HISTORIC AND DESIGN REVIEW COMMISSION

August 17, 2016

HDRC CASE NO: 2016-254
ADDRESS: 327 W CRAIG PLACE
LEGAL DESCRIPTION: NCB 1858 BLK 1 LOT 16, E 10 FT OF 15 & W 10 FT OF 17
ZONING: O2 H
CITY COUNCIL DIST.: 1
DISTRICT: Monte Vista Historic District
APPLICANT: William Triplett/H.E.B.
OWNER: Respite Care of San Antonio
TYPE OF WORK: Rehabilitations to carriage house
REQUEST:

HDRC Application
Respite Care of San Antonio
327 W. Craig Place (Carriage House), Monte Vista
Neighborhood
San Antonio, TX

Existing & Proposed Front (South) Elevation - HEB Respite Care Carriage House

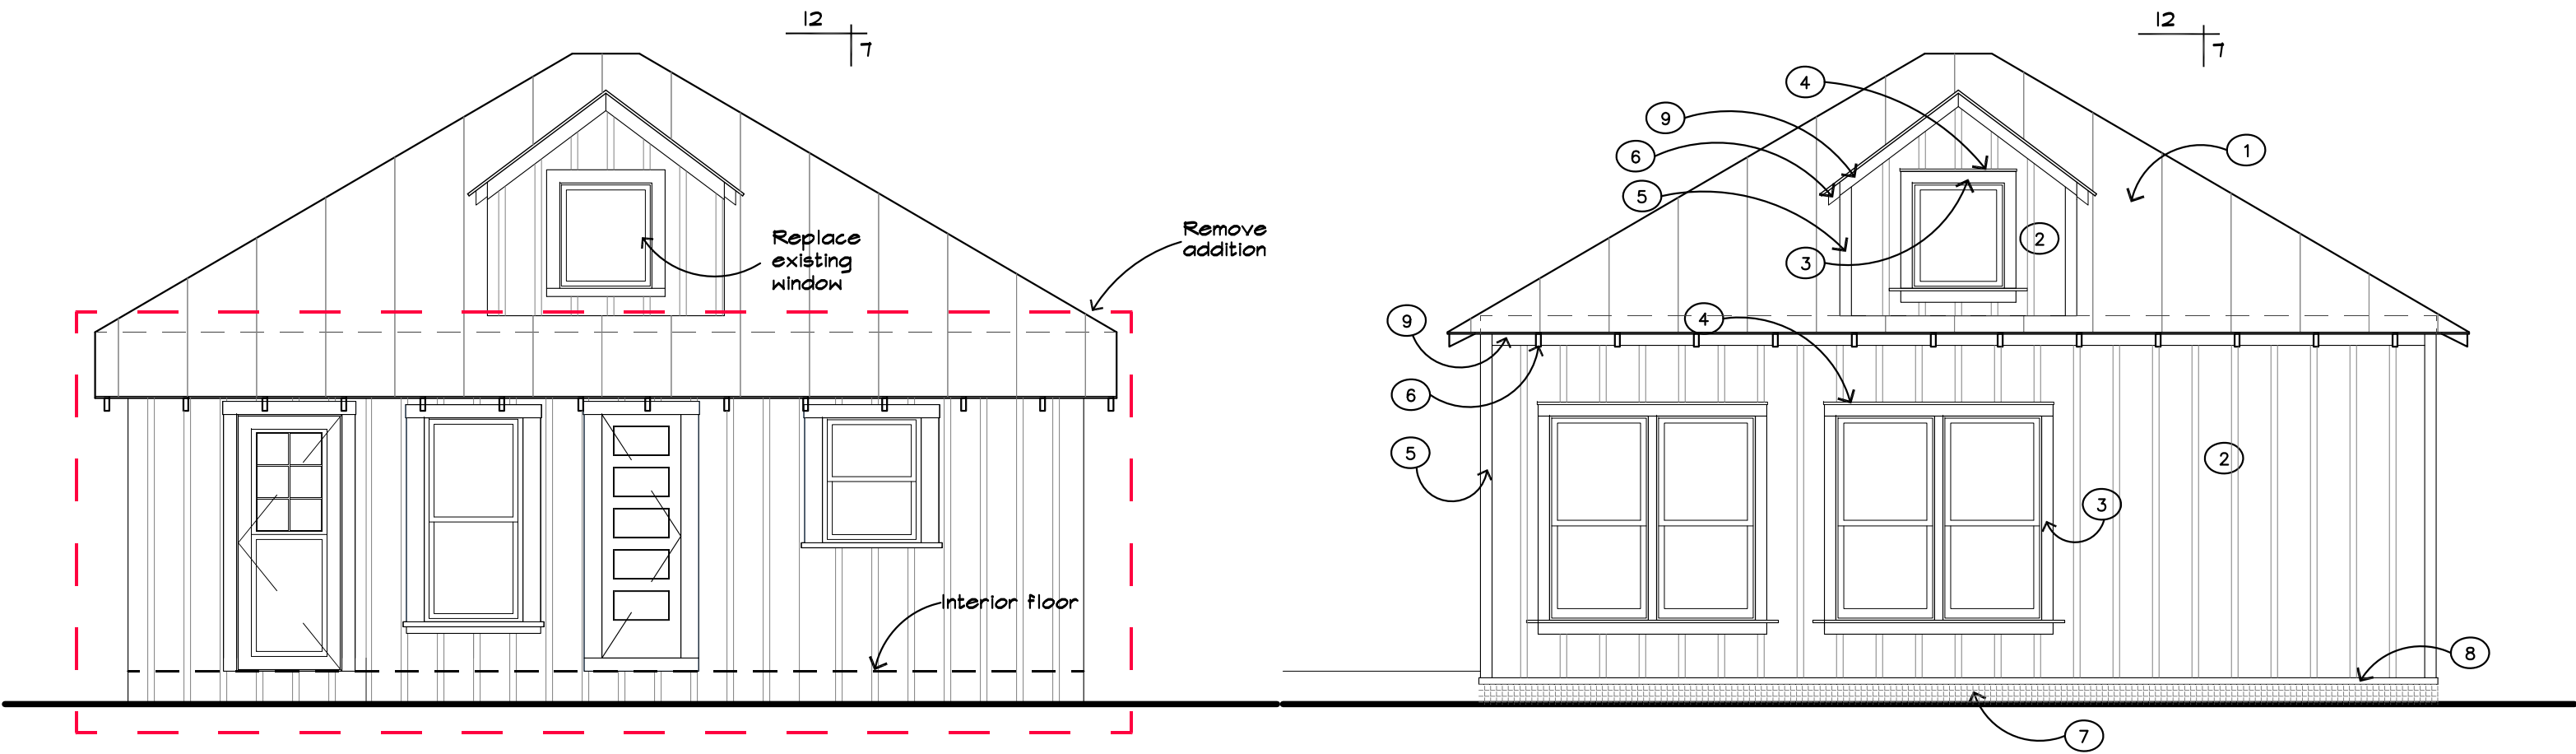
- f. There is an existing non-historic pedestrian front door. The applicant is proposing to infill the existing front door and install double doors behind two new sliding carriage doors. According to the Guidelines for Exterior Maintenance and Alterations 6.B.vii, non-historic incompatible windows or doors should be replaced with elements that are typical of the architectural style of the building. Staff finds the proposed alteration consistent with the Guidelines.

Staff recommends approval of items #1 through #9 as submitted based on findings a through k.

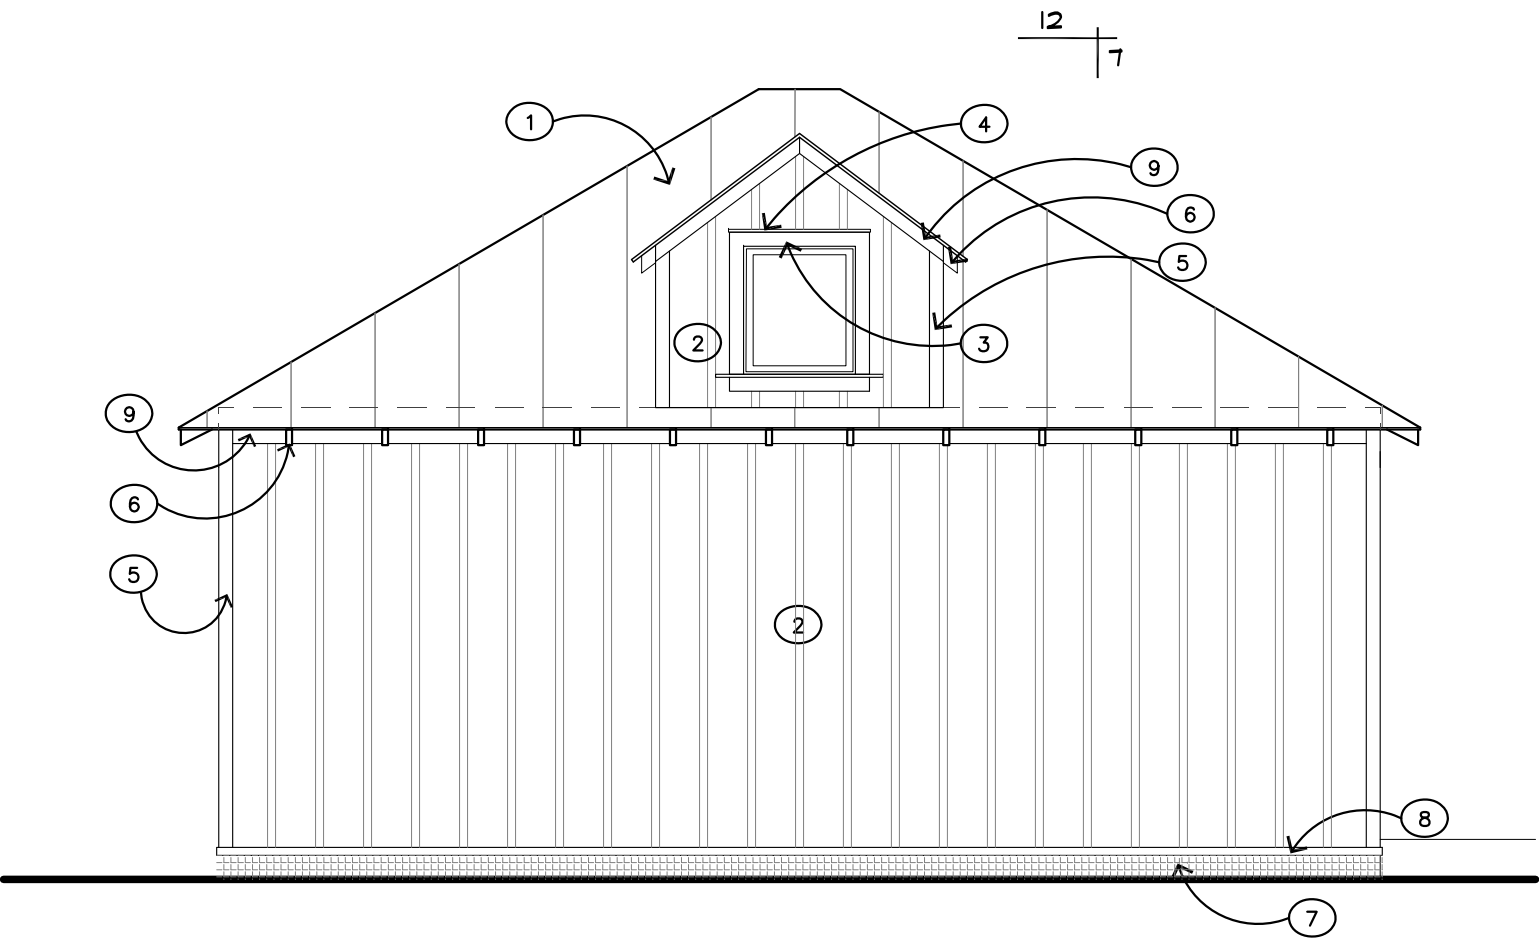
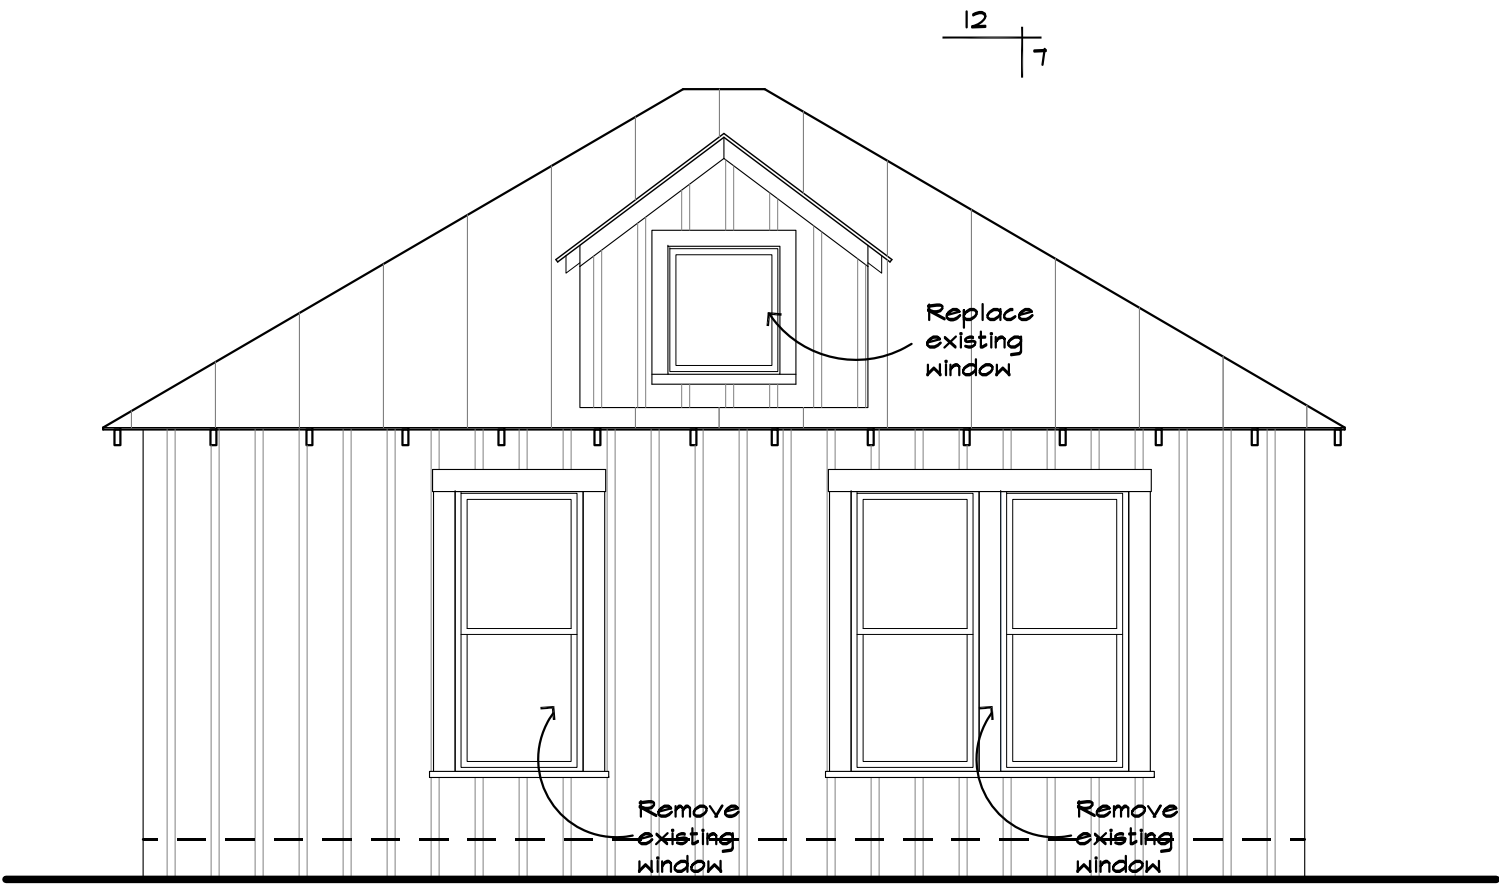
- c. The applicant is proposing to demolish the existing rectangular addition on the east side of the carriage house. The structure appears on the August 1935 Sanborn map without the shed addition. Staff finds the removal of the non-historic addition appropriate.

- d. The applicant is proposing to install 2 double wood windows, each consisting of two one over one windows on the new east elevation where the addition was removed. The new windows match the proportions of the existing one over one windows. Staff finds the new windows consistent with the Guidelines for Exterior Maintenance and Alterations 6.B.iv., which states to install new windows to match the historic or existing windows in terms of size, type, configuration, form and detail.

Existing & Proposed Left (West) Elevation - HEB Respite Care Carriage House

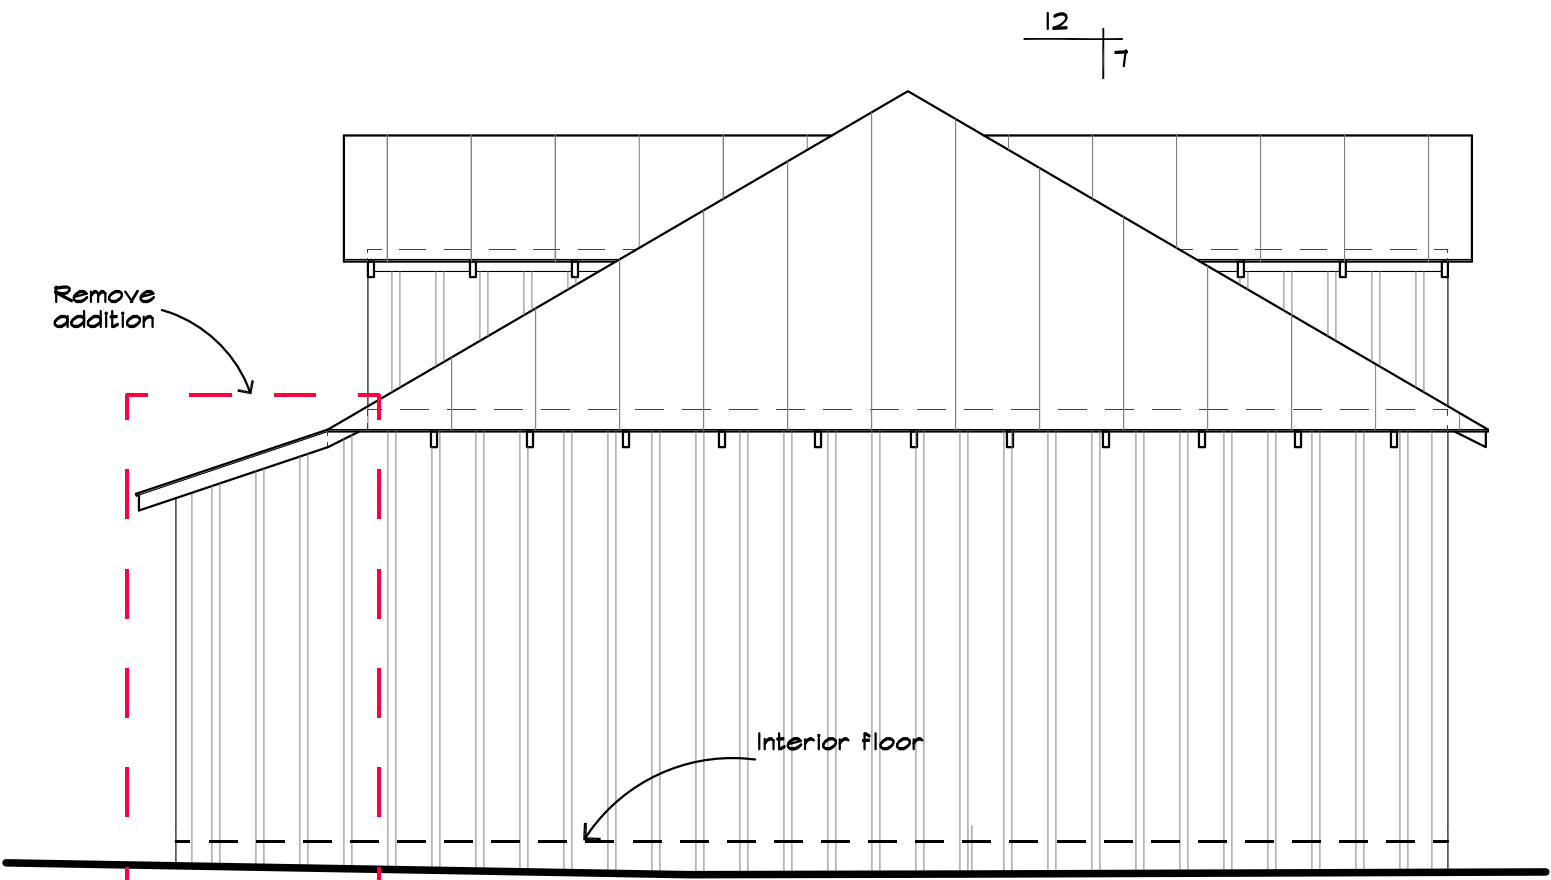
- i. The applicant is also proposing to infill 2 openings on the west elevation. According to the Guidelines for Exterior Maintenance and Alterations 6.B.i, window and door openings should be preserved. Staff made a site visit and found that the window openings not to be original. Staff finds the proposal to modify the openings appropriate.
